COMMENTS

RESPONSES

Re: Valiano Plan, PDS2013-SP-13-001, PDS2013-GPA-13-001, PDS2013-REZ-13-001, PDS2013-TM-5575, PDS2014-MUP-14-019, PDS2013-STP-13-003, PDS2013-ER-13-08-002

Wild bobcat next to the house, Valiano proposed site in background

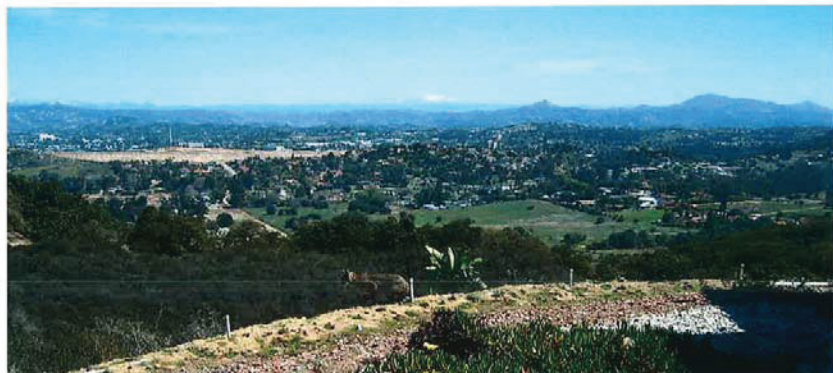
Thank you for the opportunity to comment on the Valiano project. We live on Camino de la Cima, due west of the project. The impact to us personally is tremendous and has not been assessed as part of the published study. For example, our view will contain this new neighborhood instead of the rural open spaces we bought the house to enjoy.

AO-1 See Response K-11c regarding views over the Project from Camino de la Cima. Project residences would be generally below the direct line-of-sight to the very expansive views enjoyed by the viewer from these high locations, and as demonstrated in the photograph from the home included in this comment. As shown in the commenter's letter, views would not generally be focused downward. The terrain falls away rapidly, and the eye is drawn to the horizon line of high hills and sky in the far distance.
